**CITY HISTORIC ZONING COMMISSION**  
**STAFF REPORT - CERTIFICATE OF APPROPRIATENESS APPLICATION**

► FILE NO.: 40711FTS

ADDRESS OF PROPERTY: 1416 Forest Ave 37916

► DESCRIPTION OF WORK: Demolish existing structure and replace with a duplex

Standing water in crawl space.

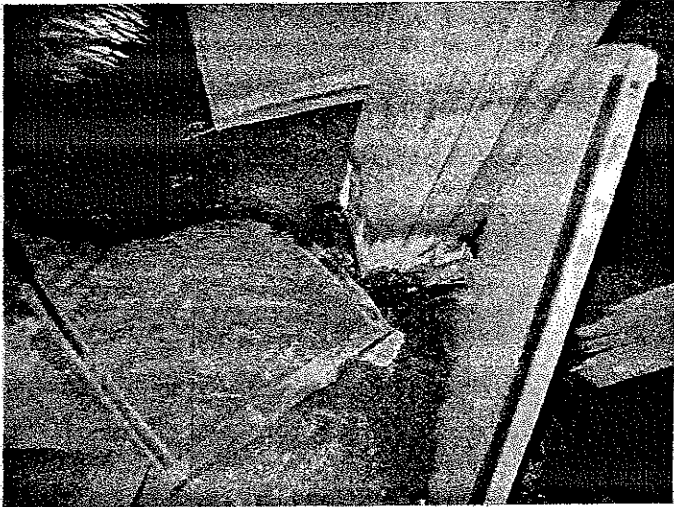
1. Although the floor framing is adequately sized for the floor load, the floors are wavy and sagging.
2. There is standing water in the crawl space. I could see one spot where water is coming into the crawl space through the brick foundation wall. The foundation walls must be excavated, waterproofed, and a foundation drain placed to capture any water that

percolates to the bottom of the footing. The foundation drain must daylight to discharge any water.

Damaged post base.

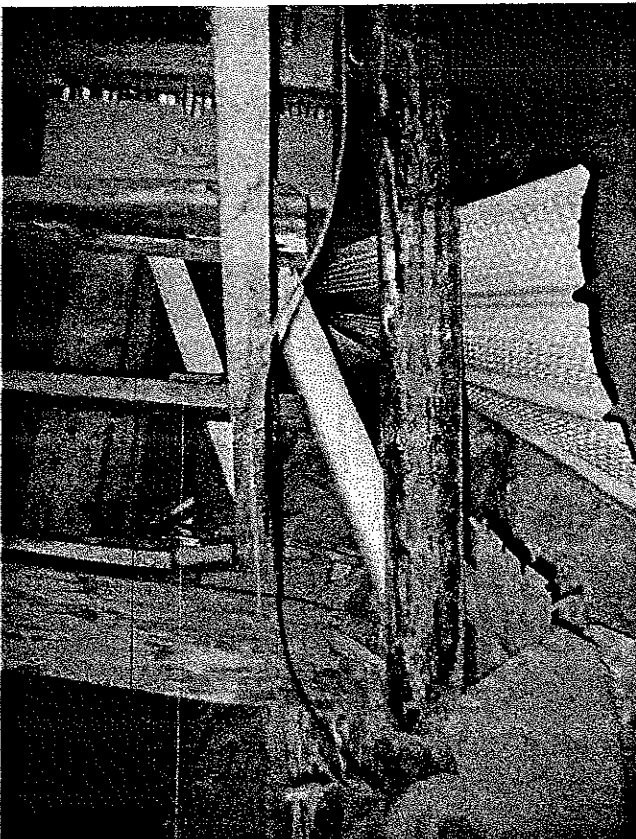
3. The wood posts that support the beams in the crawl space rest on brick or concrete piers. The wood posts do not appear to be pressure treated. This is a code violation that must be remedied by supporting the posts on a metal post base. Also, some posts show sign of water damage; these posts have to be replaced.

Stairs to crawl space to be replaced.

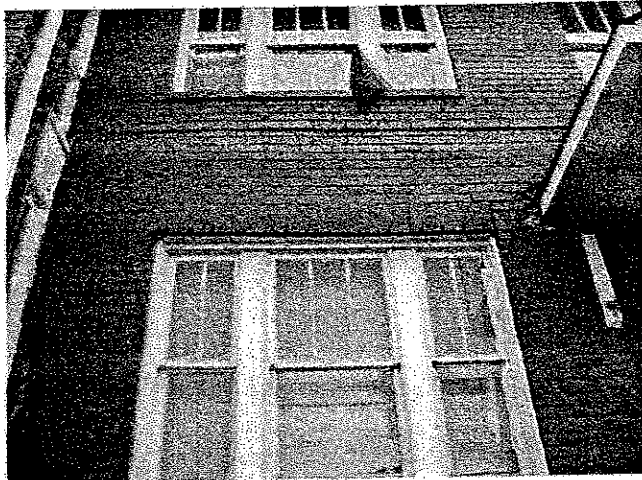
4. From my vantage point in the crawl space, I did not see any structural members that were rotted or in need of replacement, however the stairs to the crawl space must be replaced.

Sagging window lintel

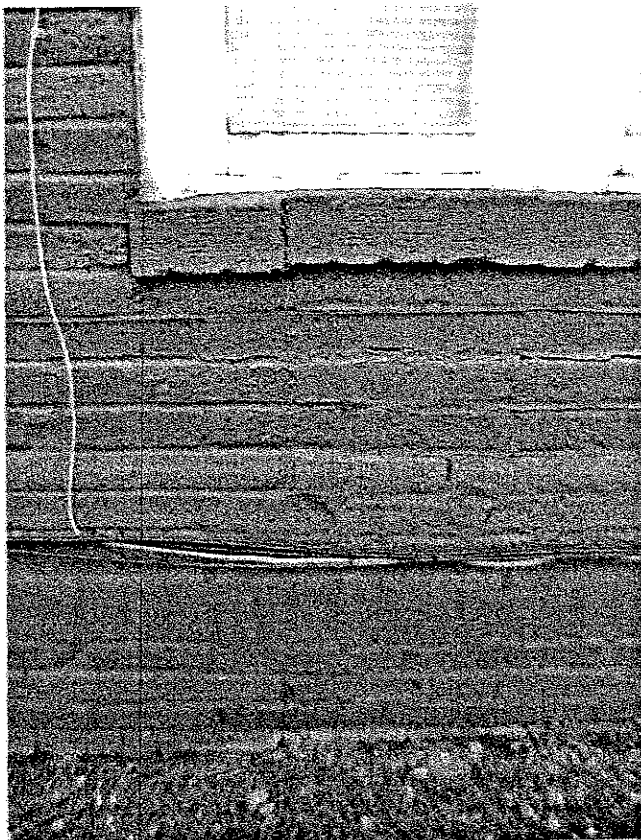
6. There are several window lintels that are sagging and must be repaired to prevent further cracking of the brick.
7. Settlement cracks on the façade where the brick is still near level can be repaired simply by re-pointing the cracked mortar joint with type N mortar. Where the brick is severely out of level, portion of the brick wall must be removed and replaced.

**RIGHT SIDE ELEVATION (FACING JAMES AGEE)**

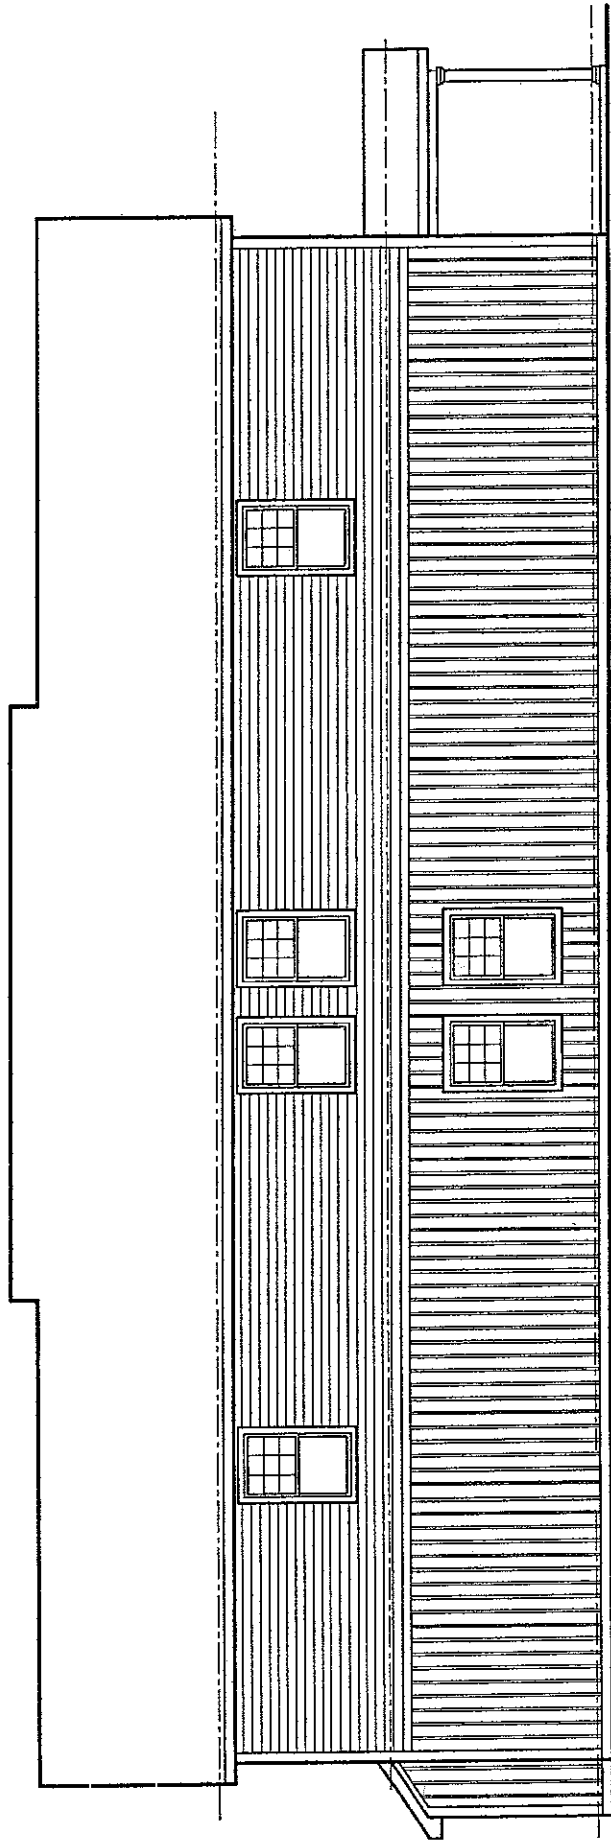
4) There does not appear to be at least 50% transparency on the Forest elevation, or the James Agee. (pg. 10, #8)

6) The requirement for bays or porches on the side elevation adjoining James Agee does not appear to have been met. (pgs 17 and 20)
